Bird in Hand Gold Project

Assessment report

Figure 15: Predicted mine inflows at 70% grouting efficiency⁷⁹

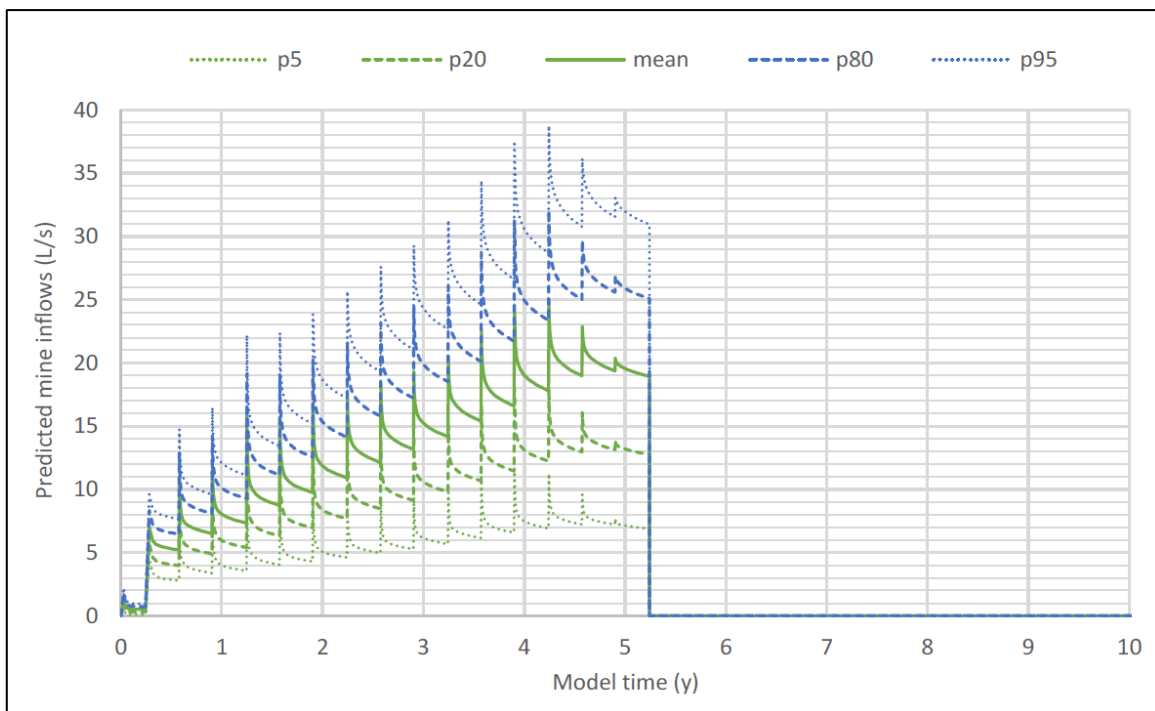
Figure 15 below shows predicted inflows for the conservative 70% grouting effectiveness scenario. As discussed in the preceding MAR section of this chapter DEM consider it appropriate for the MAR system and water treatment plant to have appropriate redundancy to handle higher than expected inflow associated with this scenario. Figure 4 shows the median (P50) peak inflow rate during mining at 25 L/s in year 5. The conservative (P95) shows an inflow rate of 39 L/s in year 5.

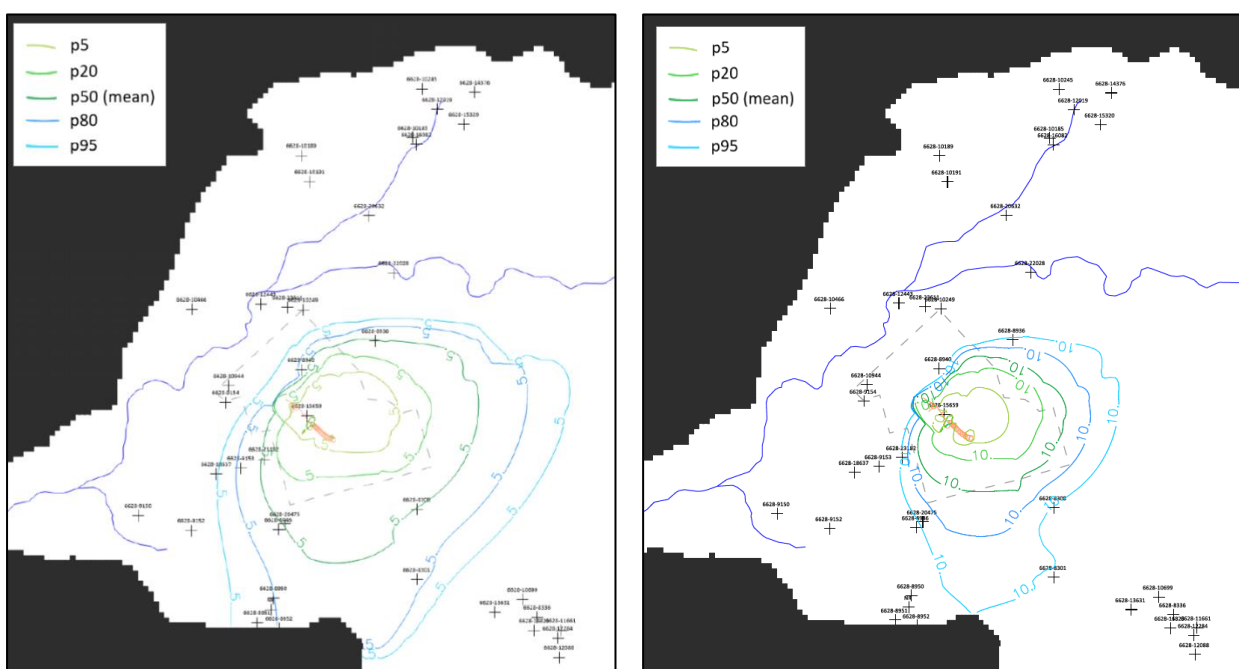
Figure 16 shows that the predicted maximum extent of 5 m drawdown for the “hybrid” scenario without MAR will affect 4 receptor wells, for the median (P50) value, noting a fifth well directly over the mine is owned by Terramin. The conservative P95 contour includes 12 receptor wells. In comparison the P50 contour showing predicted maximum extent of 10 m drawdown for the “hybrid” scenario does not impact on any receptor wells. The P95 contour includes 4 receptor wells.

Figure 2 Histograms of equivalent hydraulic conductivity of zones Kh_23 and Kh_24 (Layer 5, proposed mine area), based on 10,000 random samples. The numbers in brackets are respectively the mean and standard deviation.

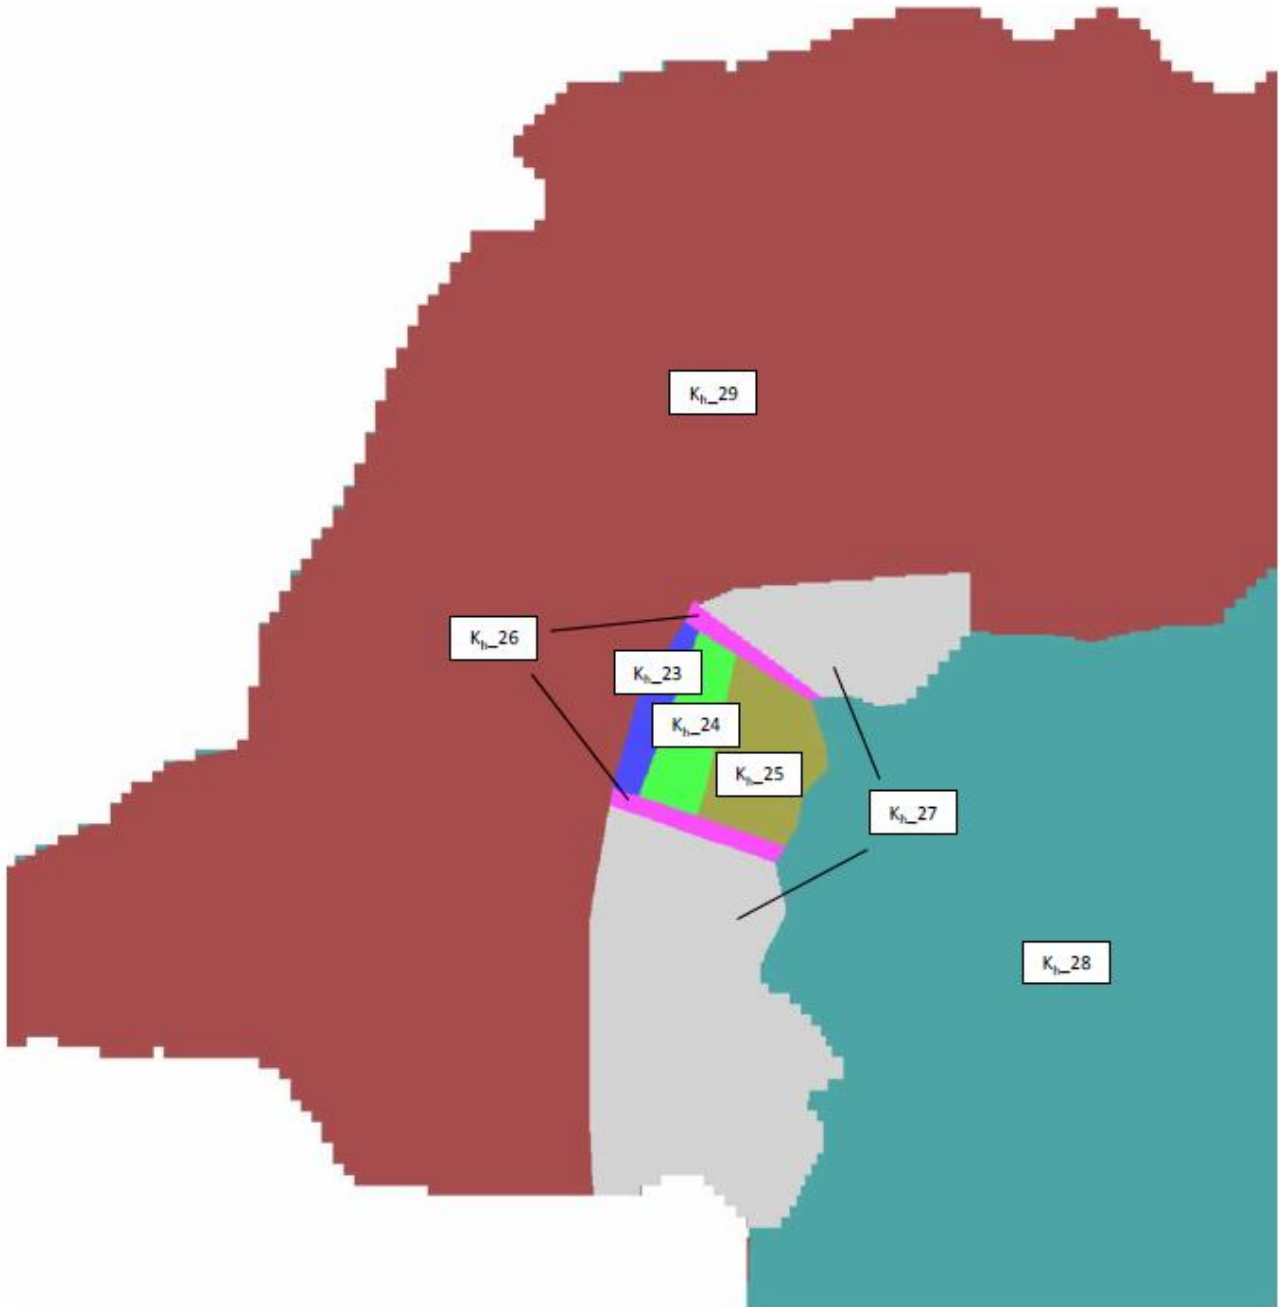
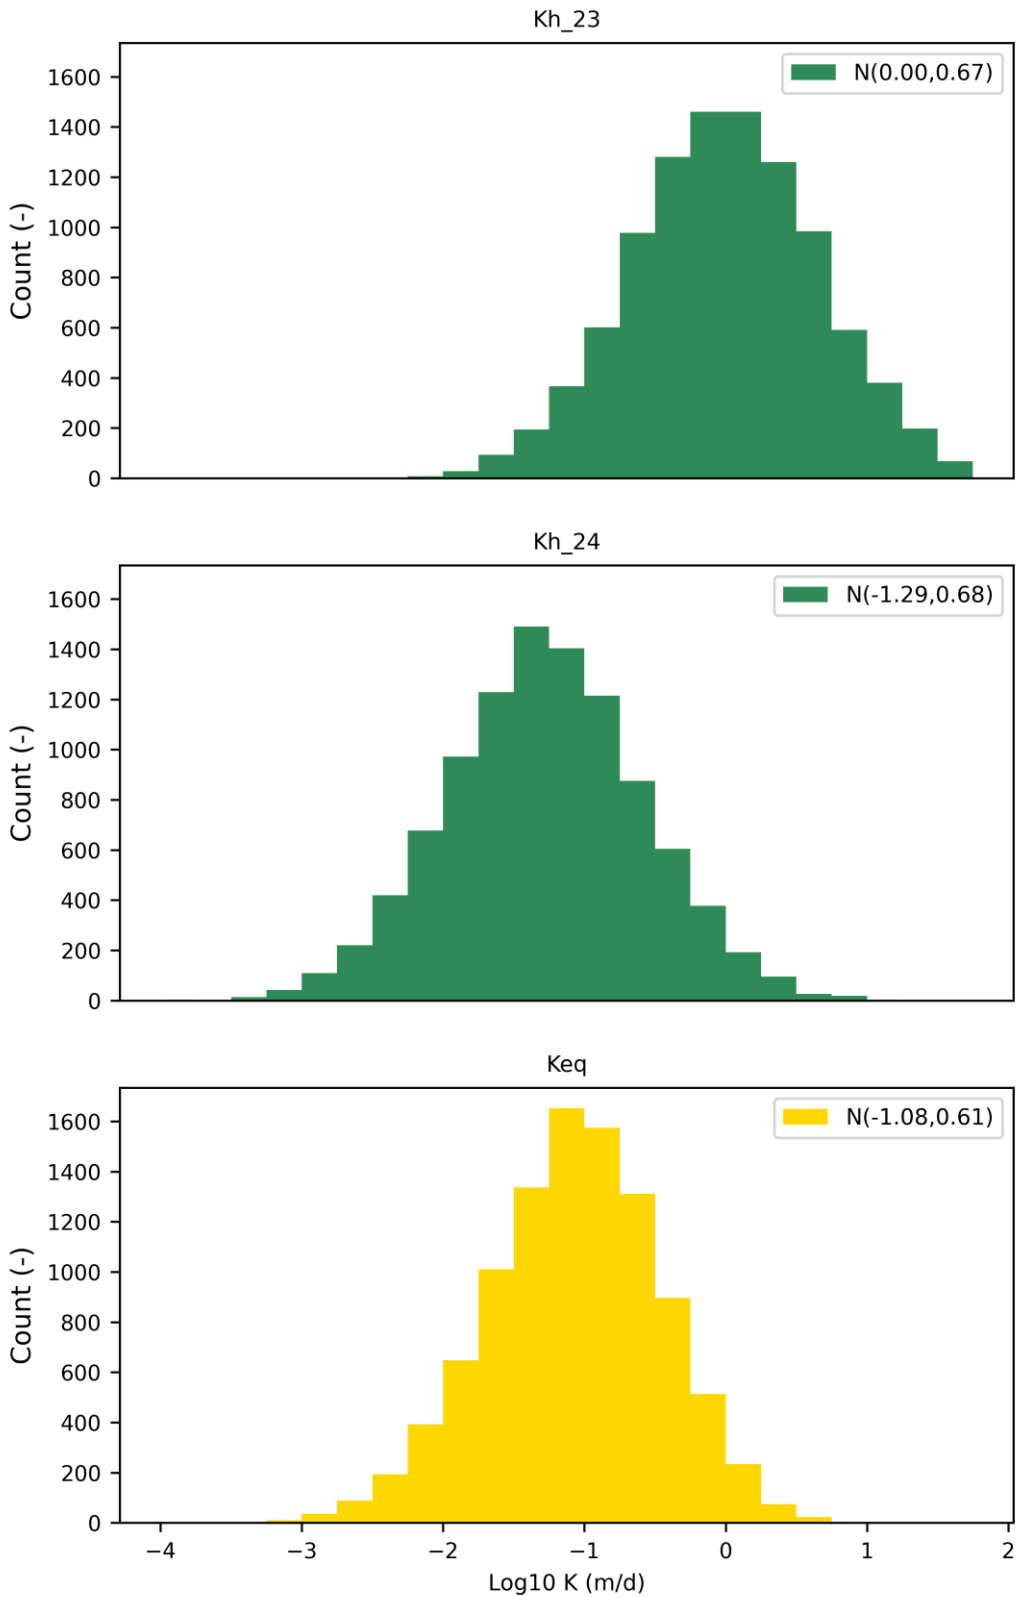
The posterior distribution after rejection sampling is very similar to the prior distribution for both parameter zones, with a standard deviation that is designed to cover 2 orders of magnitude (0.67 of log₁₀ K). Figure 2 shows the equivalent log₁₀ hydraulic conductivity distribution calculated using Eq. 2 for 10,000 random samples drawn from the normal distribution with mean and standard deviation for Kh_23 and Kh_24 taken from the prior values in table 7 in Appendix B7A.

This figure shows that the standard deviation of the distribution of the equivalent hydraulic conductivity values is 0.61, which is smaller than that of the individual parameter zones.

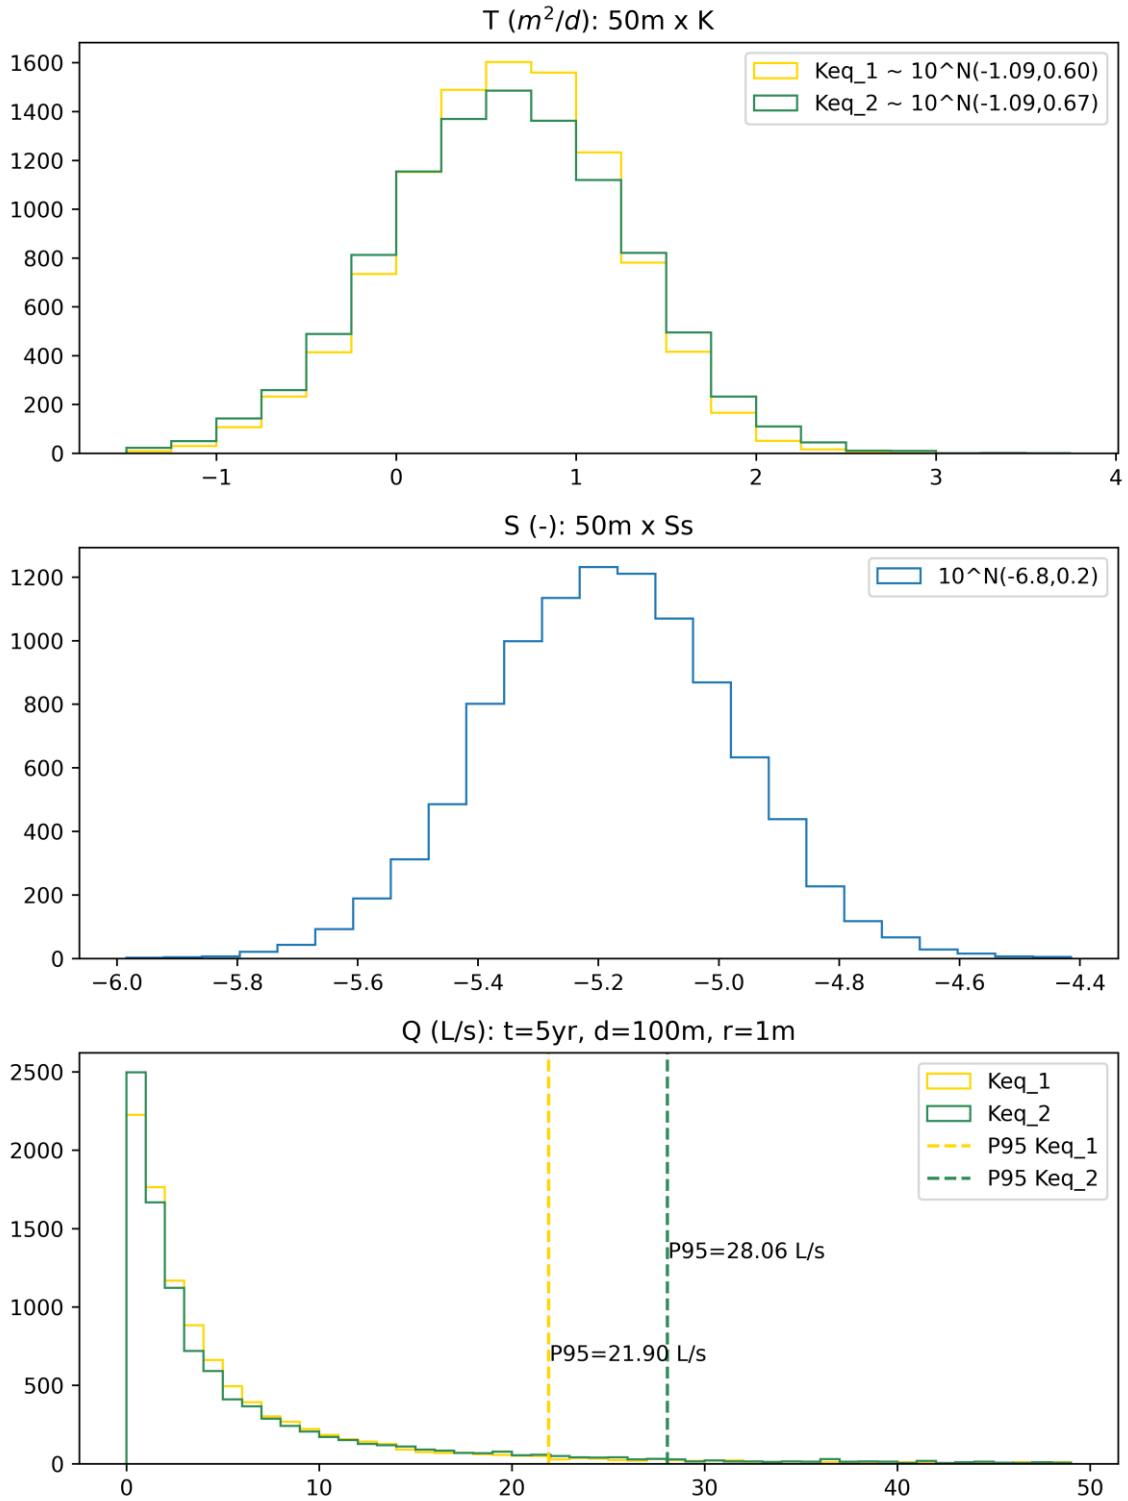
The predicted inflow distributions shown in Figure 3 are very skewed, with a long tail. This means the prediction interval is not symmetric; the 5th percentile will be close to the 50th percentile, but the higher percentiles (70th, 80th, 95th percentile) will be much larger than the 50th percentile.

We also note that the histograms for SRMS (Fig 1 in Appendix B7A) and calculated baseflow (Fig 2 in Appendix B7A) also show skewed distributions, but the distribution of predicted inflow (Tables 1

to 3) are symmetric (i.e. the difference between P50 and P95 and between P50 and P5 is similar). This is not consistent with the expected skewed distribution on theoretical grounds. Without a comparison of parameter values retained in the ensembles against the prior or posterior, it is not possible to conclusively evaluate whether this an artefact of the modelling or an adequate representation of reality. We speculate that higher values of transmissivity or storativity cause numerical issues, leading to large water balance errors. If these values are rejected because they cause numerical instability rather than because they are physically not realistic, it will also lead to an underestimate of the P95 of inflows.

Figure 4 Convergence of 5th, 50th and 95th percentile for inflows calculated with Keq_1 and Keq_2. The bottom plot shows the first 150 realisations only.

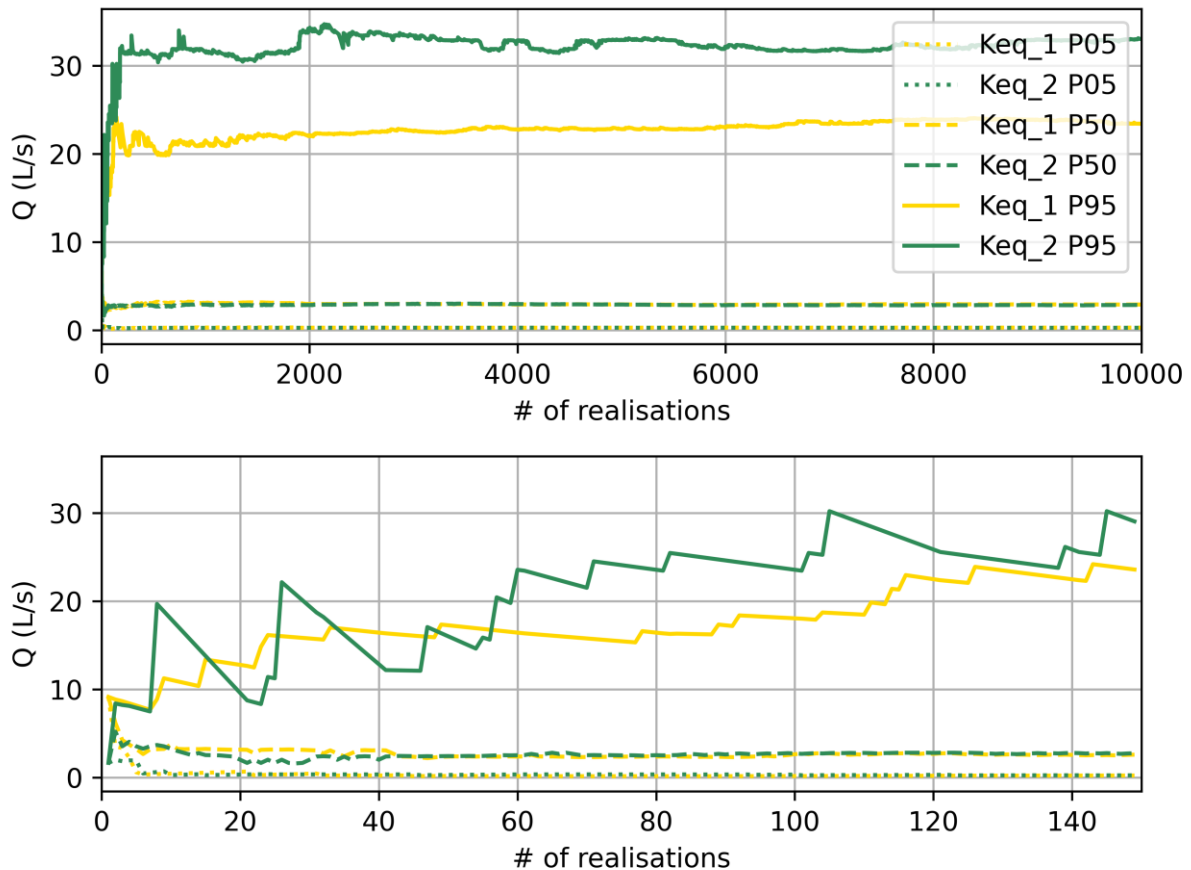
The bottom plot of Figure 4 shows only the first 150 realisations. This plot is similar to those presented in Appendix B7A (Figure 46 to Figure 52). Considering the bottom plot in isolation may lead to a conclusion that the results have converged, but comparison with the top plot illustrates that this conclusion is not justified. In this specific case, the P95 for inflows calculated with Keq_2 is underestimated. It has to be noted that insufficient sampling can lead to either an underestimate or an overestimate.

Figure 4 also shows that the 5th and 50th percentile for the inflows calculated with Keq_1 and Keq_2 are almost identical. This provides confidence in the median mine inflow rates calculated with the numerical groundwater model.

Figure 6 Model discretisation and layering (Fig. F4 in Appendix H1)

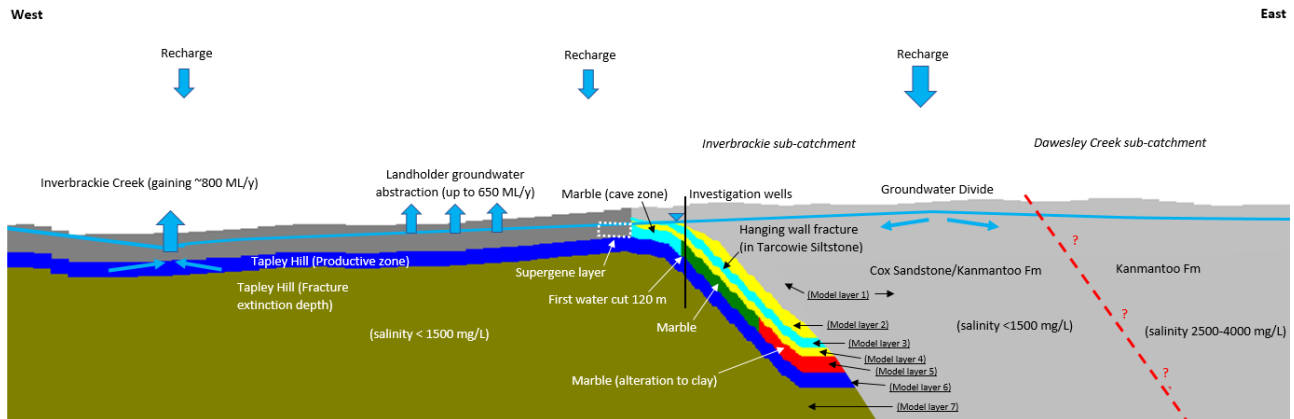
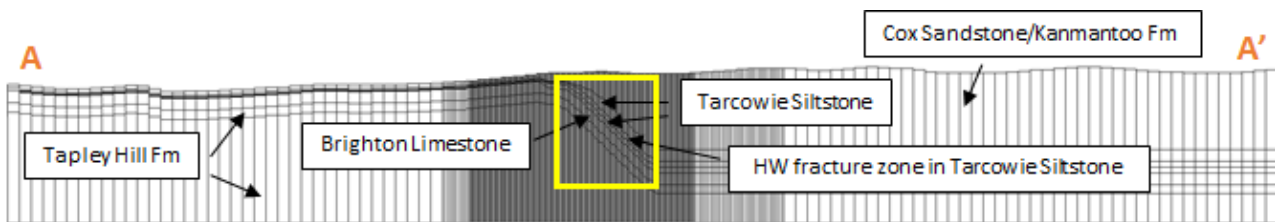
The MLA is in a fractured rock aquifer, where hydraulic parameters are dominated by the secondary permeability (faults and fractures) with less influence of lithology. The hydrostratigraphic units in the hydrogeological conceptualisation do largely follow stratigraphy (Figure 5). This is consistent with the information presented in the groundwater assessment reports.

Figure 6 shows how this conceptualisation of hydrostratigraphic units is translated in the discretisation and layering of the numerical model. Hydrostratigraphic units are largely represented as individual layers. The layers in the vicinity of the fault zone and the mineralisation are steeply dipping. This creates following issues:
